Job Stamp
04-0120F4
SFOBB SAS

REQUEST FOR INFORMATION (RFI)

RFI No.: ABF-RFI-001626R00 Submitted By: Lewis, Michael Pages: 4
 RFI Date: 29-January-2009 Contact Name: Lewis, Michael Pages Attached: 3
 Phone No. 510-808-4600

Subject: W2 Luminaire Pedestal Reinforcement	
References: Sheet of 905R1 of 1204, Attachments 1, 2, and 3	
Sub/Sup: ABF	Sub RFI #:
Response Required by: 29-January-2009	Response affects critical path activity? Yes

ATTACHMENT 1

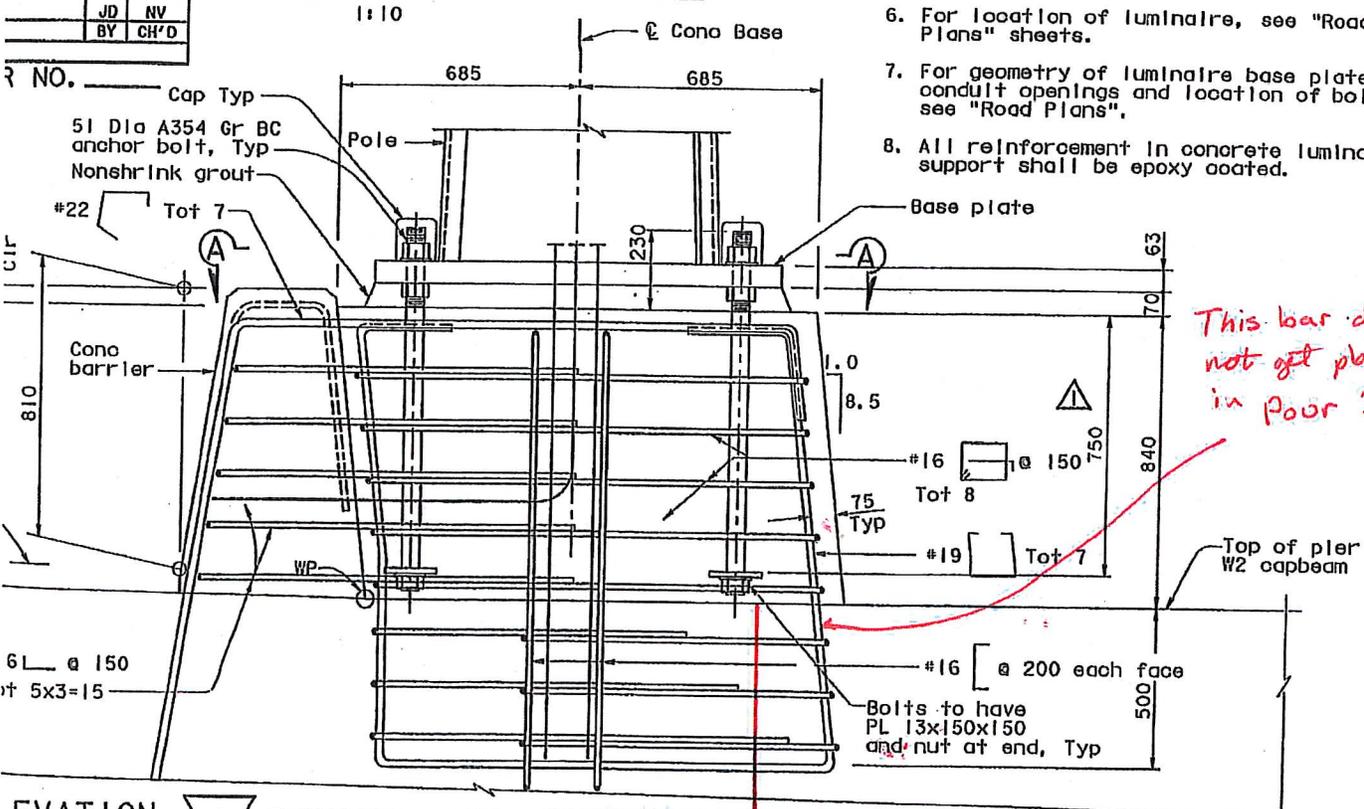
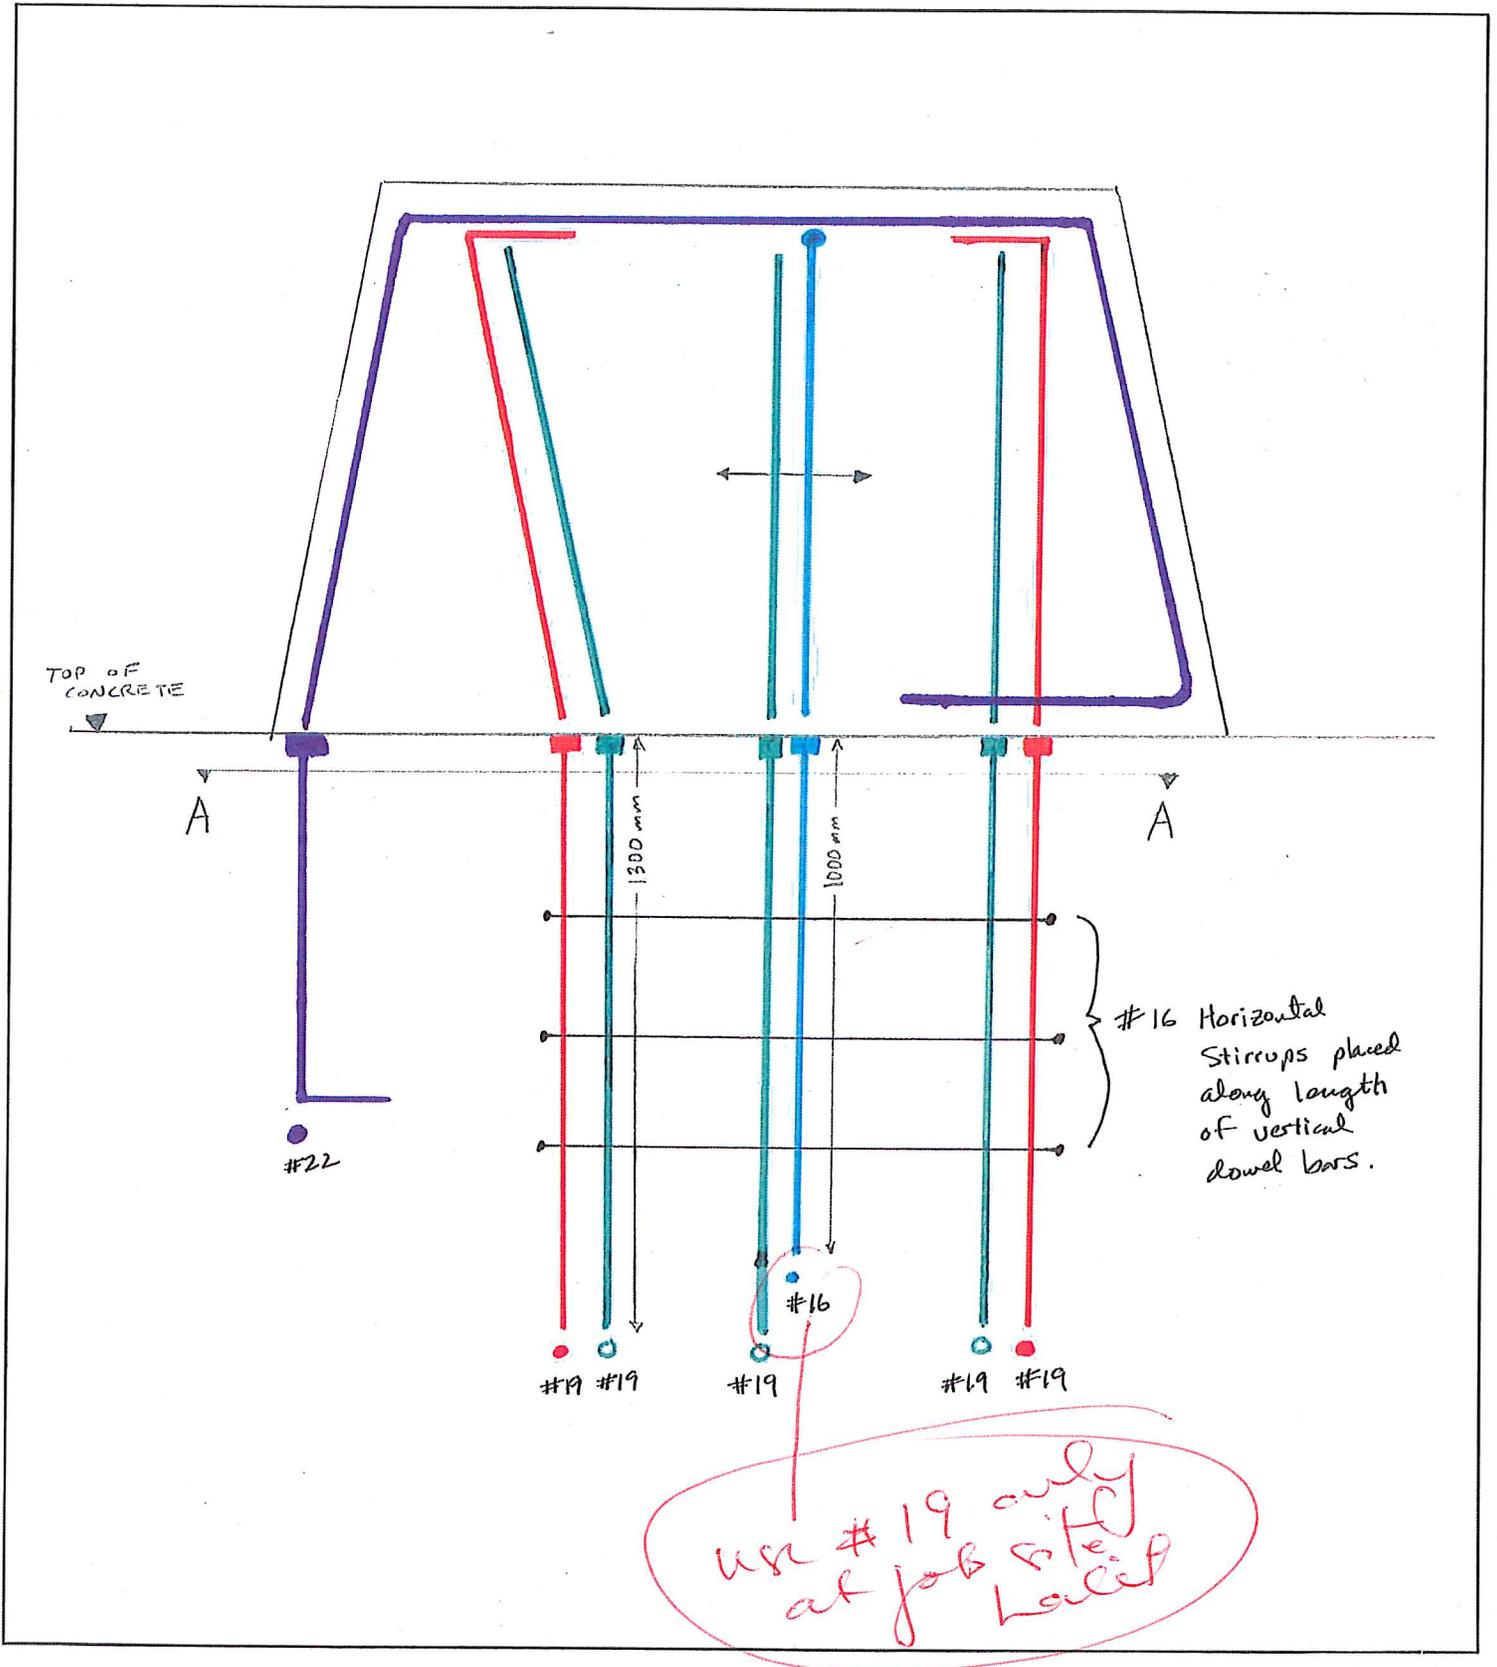
ABFJV proposes altering the luminaire pedestal reinforcement at the W2 Cap Beam as shown in Attachment 2 and 3. This change is necessary, as some of the pedestal reinforcement was not placed in the Pour 3 concrete (as shown in Attachment 1, marked-up sheet 905R1). With the omitted reinforcement, the pedestal cannot be constructed per plan sheet 905R1. The proposed change would use straight reinforcement dowels (in lieu of the bent U-bars per sheet 90R1) within the concrete with couplers along the concrete top surface placed in accordance with ABF-RFI-000502R01. The reinforcement dowels used will be #19 (1300 mm embedment) and #16 (1000 mm embedment) in the positions shown per the attached. Additional #19 reinforcement dowels will be located per Attachments 2 and 3 to compensate for the omitted reinforcement. As an additional alteration, the three #16 horizontal stirrups will not be located within 500 mm from the top surface of concrete as shown on sheet 905R1 (Attachment 1). Instead, these stirrups will be located anywhere along the length of the dowels such that they are not bundled together or located only at the tail end of the dowel bars as shown on Attachment 2.

- Discussed with Gil about the RFI 001626R00 for Luminaire Pedestal. The pedestal extends on top of the Pour 3 concrete and the rebars were not doweled in it. Gil mentioned that he has talked to James of TY Lin and he has no objection to this revision. I called Ron to approve this and let Jim Davidson know in advance so that they can go ahead with the work.

SECTION A-A

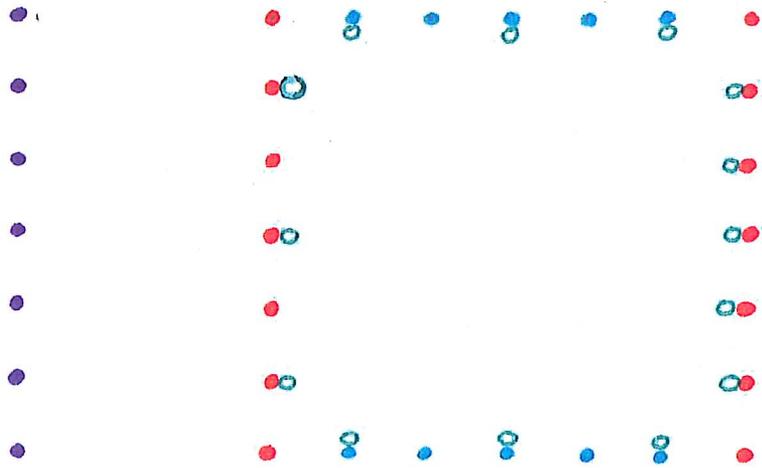
Please confirm that ABFJV's proposed reinforcement alteration by is acceptable.

Nigel mentioned that they will use # 19 bars in lieu of #16 bars mentioned in the RFI because they do not have #16 bars in the length mentioned in the RFI. We had no objection to this. These will be installed tomorrow morning.

used #19 at job site
Lalit
